## Request for Class II Permissive Change

FCC ID: **YZZ HT701V21** Data: November 26, 2012

Original mainboard photo view

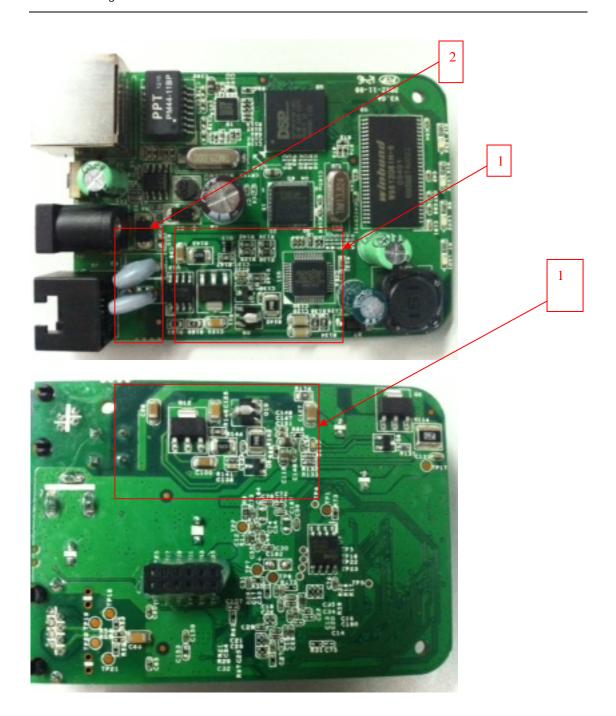
- 1. Upgraded mainboard hardware version from HT701 V2.1A to HT701V3.0A;
- 2. Changed component layout& PCB layout, we only replace an integrated chip (N681622YG) by discrete circuit for better performance(see arrow 1);
- 3. Change PTC from 9 ohm to 50 ohm(see arrow 2); Anything else are the same as before.
